AGENDA ITEMS 4B, 4C, 4D, & 4E

Lot 3 Echo Hills
West Management LLC

RECOMMENDATION REPORT

CASE NUMBERS: PCPA19-0002;
PRZ19-0002; PPUD19-0004; PSPP19-0003

Site Plan

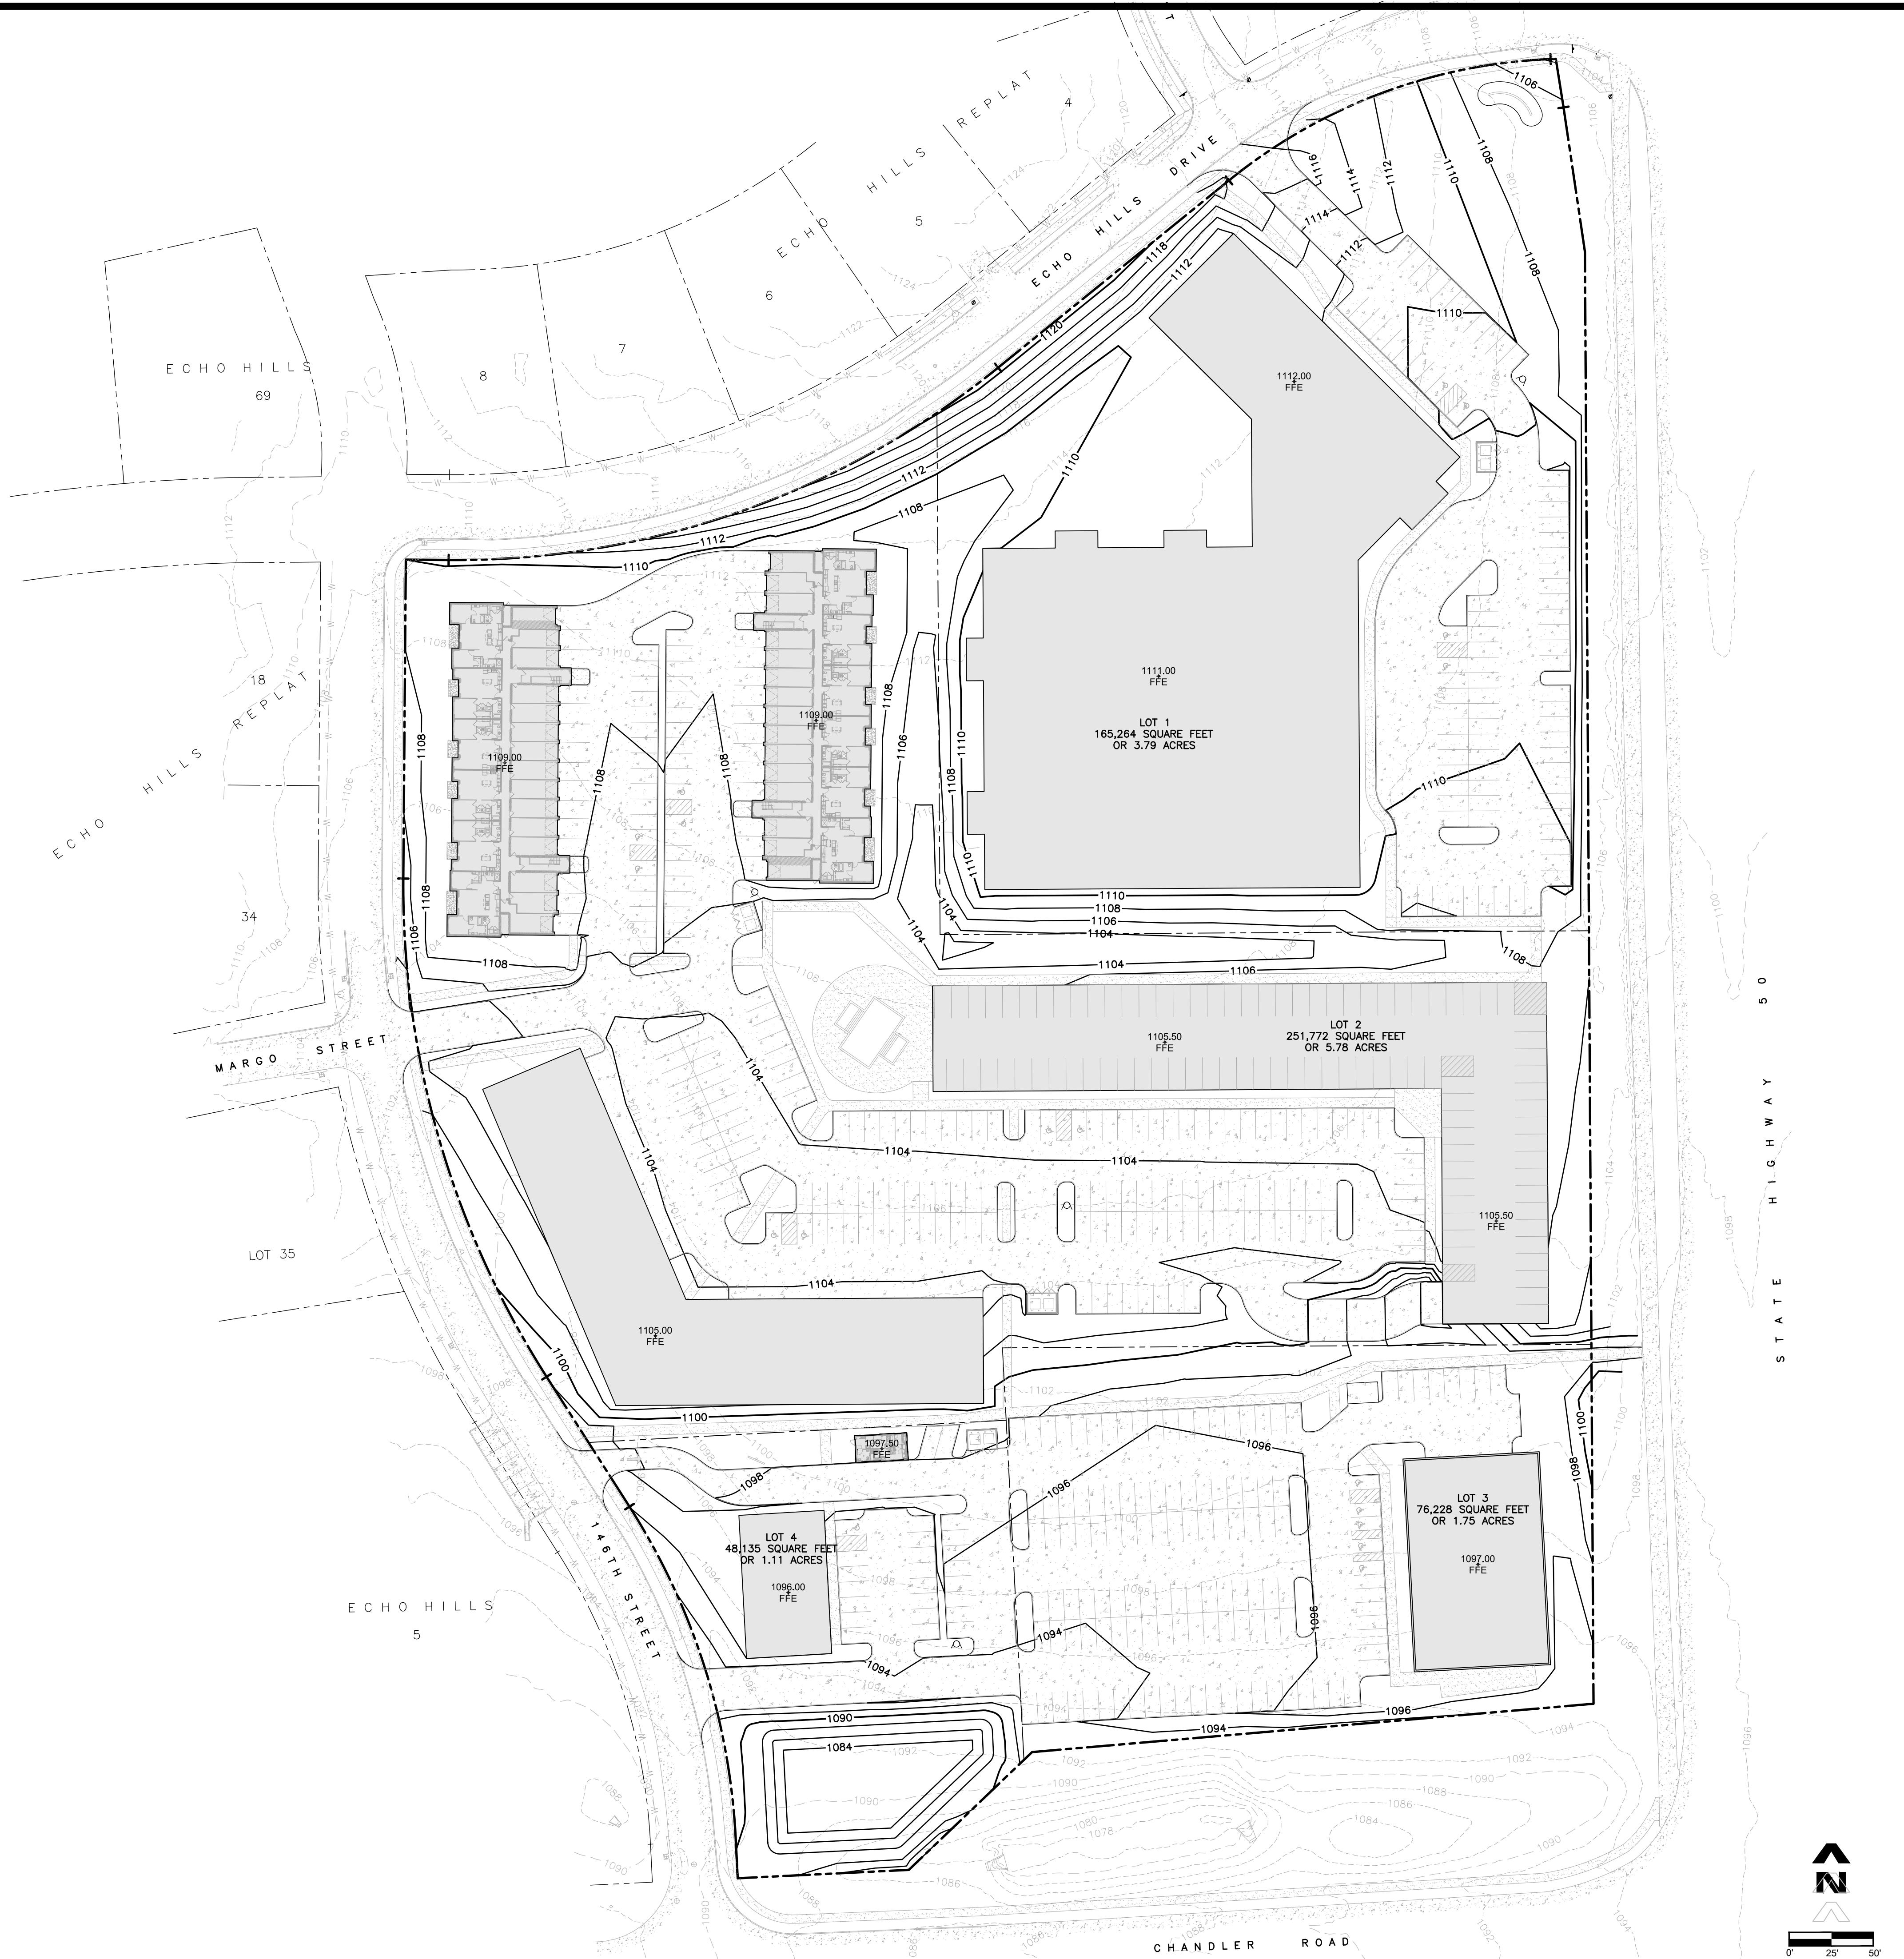
1. Section 5.15.03 – The zoning listed on the PUD Site Plan needs to be corrected to include the Gateway Corridor District (Overlay District) over all parcels to reflect the actual zoning.

7. Section 5.15.04.09 – The residential structures within the PUD Site Plan do not meet the 30-foot front yard setback requirement of the proposed underlying R-3 Zoning District. However, these setbacks do meet the minimum requirement of Section 5.15.04.09 of the Zoning Ordinance when found reasonable by the Planning Commission and City Council as per that section of the Ordinance.

The smaller building depicted on Lot 4 does not meet the setbacks within the underlying C-1 Zoning District as listed within Section 5.10.06 of the Zoning Ordinance.

8. Section 5.15.04.11 – The open space percentage listed for Lot 2 does not conform with the 30% requirement as set forth in this Section.
9. Section 5.15.04.14 - The proposed commercial parcel has significant access restrictions to 144th as well as Chandler Road per NDOT. However, 146th Street is in proximity of Chandler Road as well as 144th Street and would generally act a local collector. Similar roadway configurations can be found in the adjacent Stonybrook South subdivision.

10. Section 5.15.04.15 - PUD plan needs to show five foot (5') wide sidewalk dimensioning on public street frontages.
11. Section 5.15.04.17-20 - The overall site and landscape plans are currently under review by the City's Design Review Architect. A separate design review letter will be forwarded once the initial review has been completed. The design review process for these plans needs to be substantially complete prior to proceeding through City Council approval process.

14. Section 5.15.05.02, Subsection 2 - Height of each proposed structure needs to be addressed within the PUD plan.
15. Section 5.15.05.02 Subsection 4 - Ensure pedestrian walkways for internal circulation and connections to the perimeter sidewalk are adequate. The parking island immediately east of the 12 parking stall group south of west leg of Building 3 should be shifted west to align with the north/south sidewalk connection going through the parking lot. Additionally, a connection should be made between the east/west sidewalk along the northern end of the commercial property to the sidewalk along the west face of the south leg of Building 3.

1. Section 5.15.03 - The zoning listed on the PUD Site Plan needs to be corrected to include the Gateway Corridor District (Overlay District) over all parcels to reflect the actual zoning.
Okay, Site Plan has been updated.

Acknowledged. Residential structures are setback 25' from the property line per 5.15.04.09.

Per Section 5.15.02.04, we request the side yard setback of 10' be adjusted to what is shown on the PUD Site Plan.

Acknowledged. Lot 2 open space was displayed incorrectly on the Site Plan. The correct open space percentage is 34%.

Acknowledged. Label has been added.

Building Heights have been added to the Site Statistics Table.

Site Plan has been updated per comments. The sidewalk connection on the west side of the south leg of Building 3 to the commercial lot is not shown due to elevation differences.

PUD Landscaping Plan

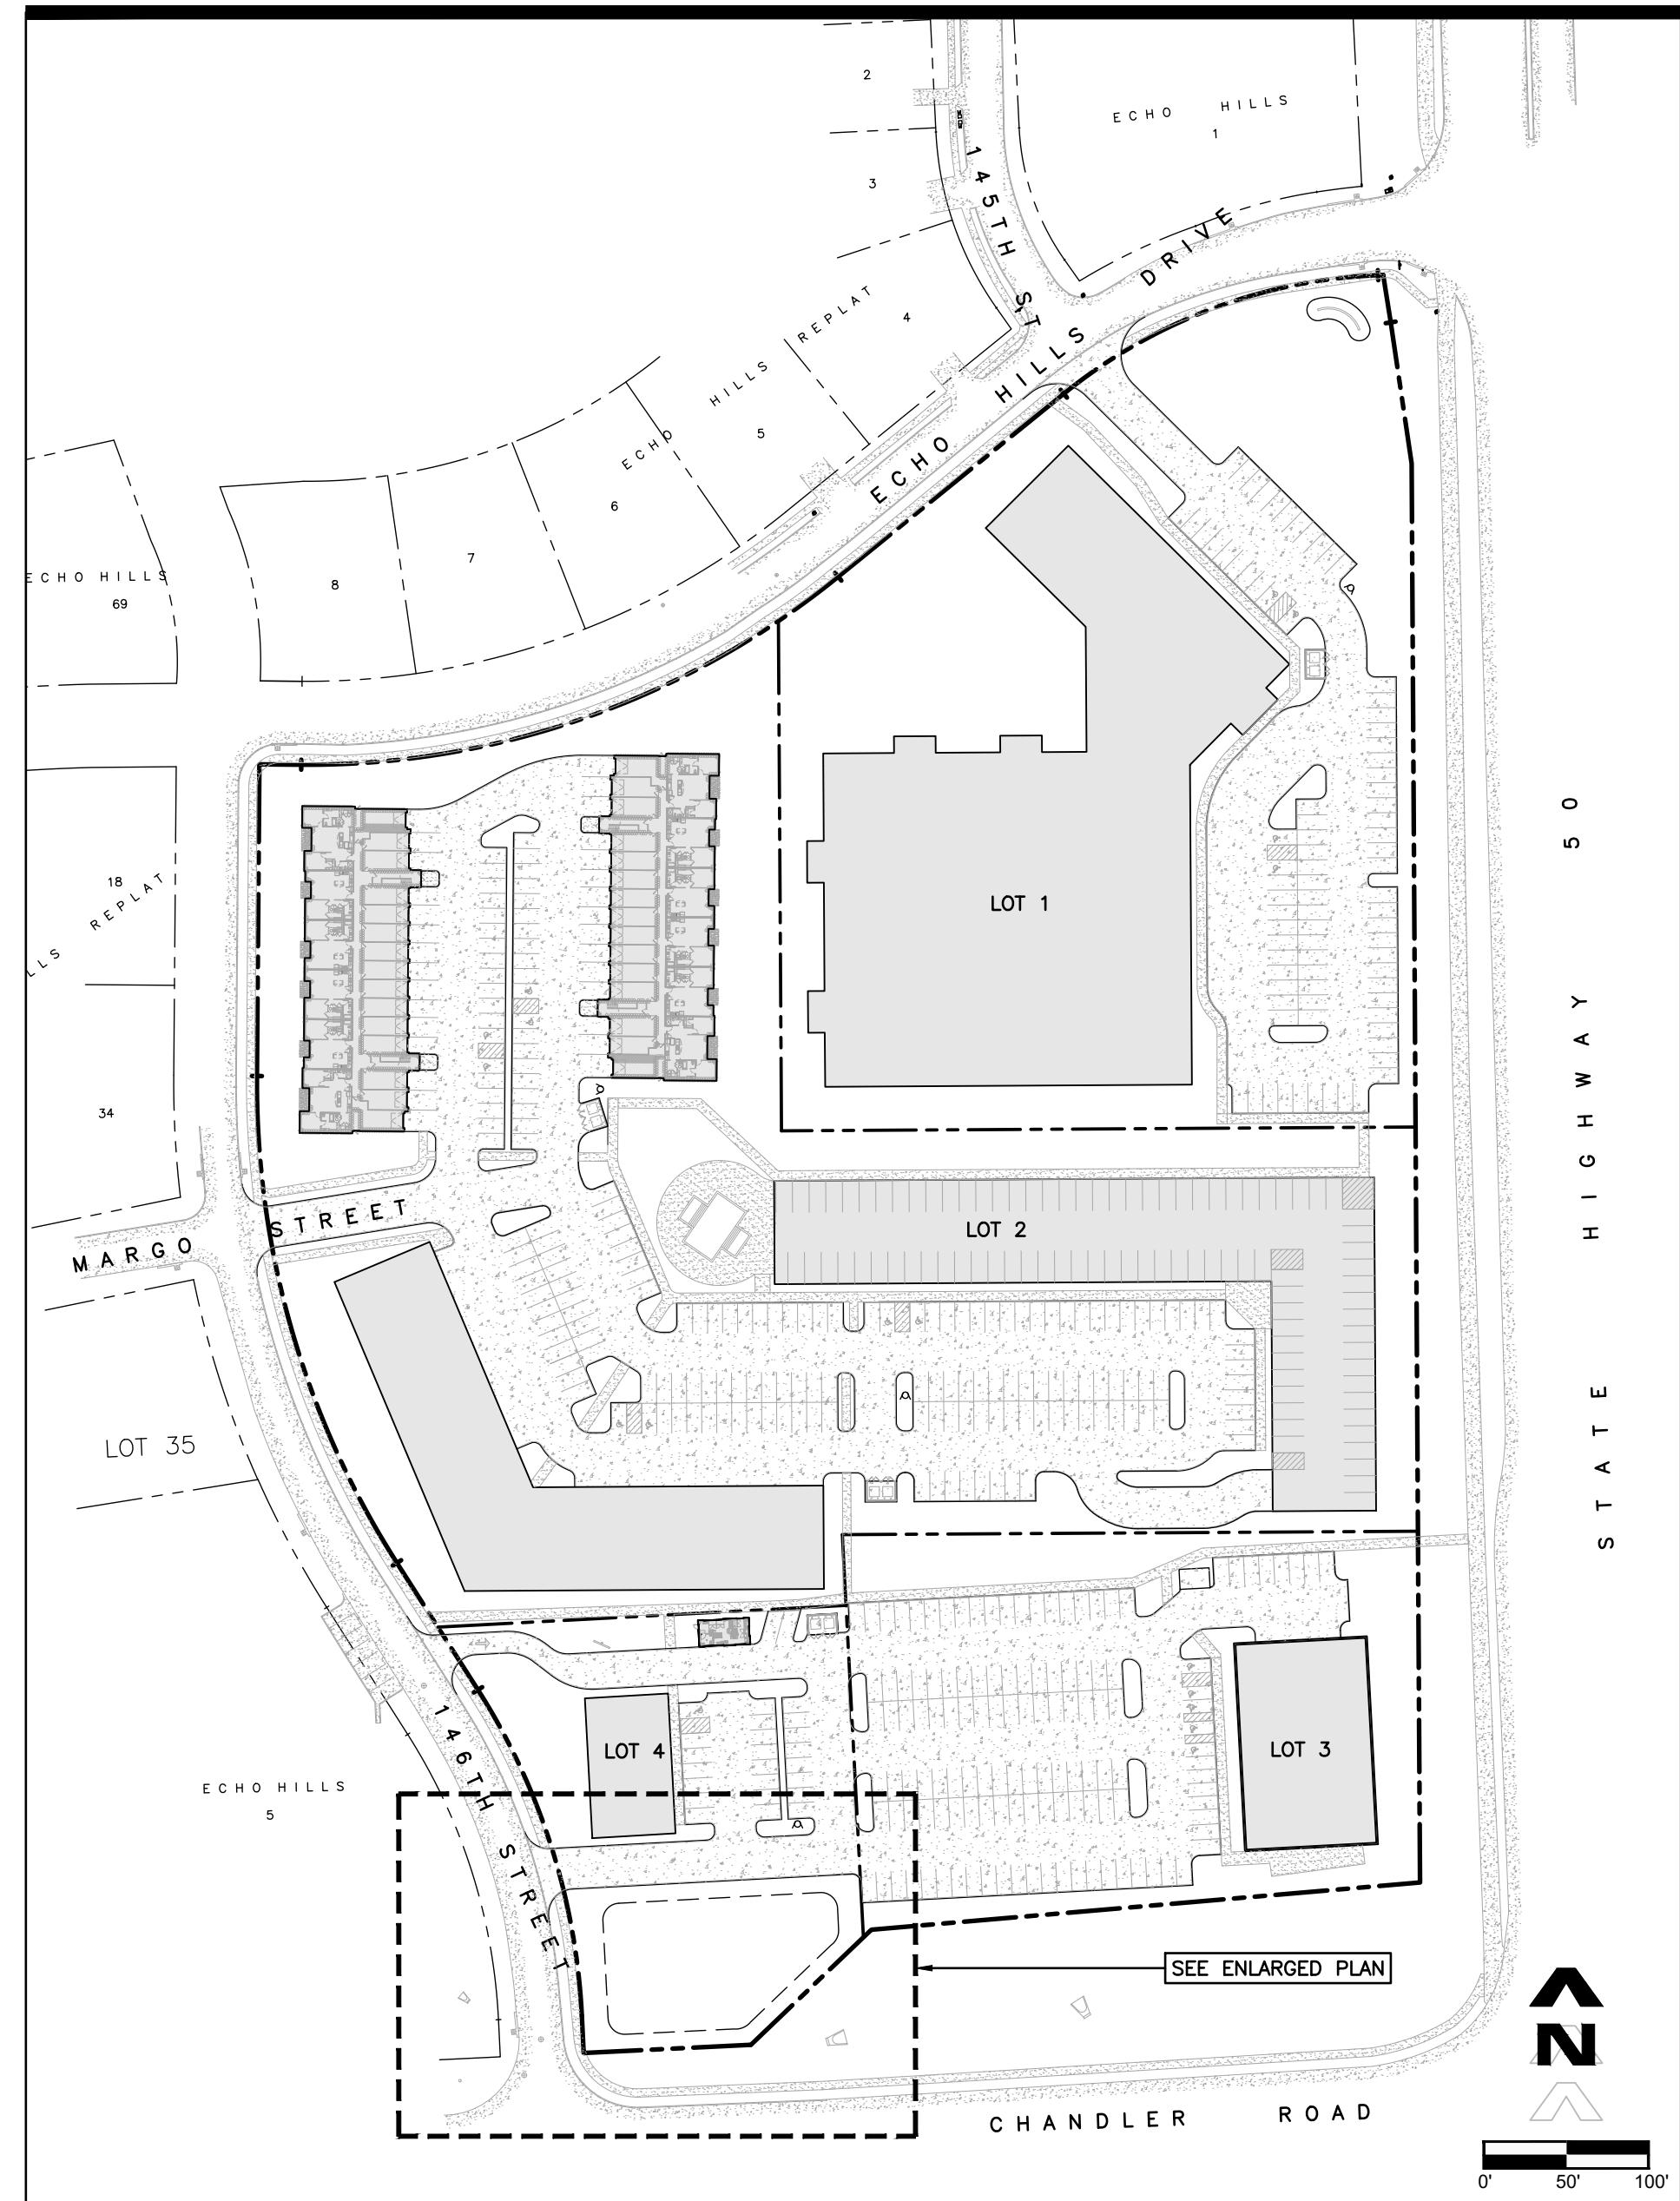
8. General Comment: A review of the proposed PUD Landscaping Plan is currently under review by the City's third-party Design Review Architect. Once the review is complete, alterations to the Landscaping Plan may be required.
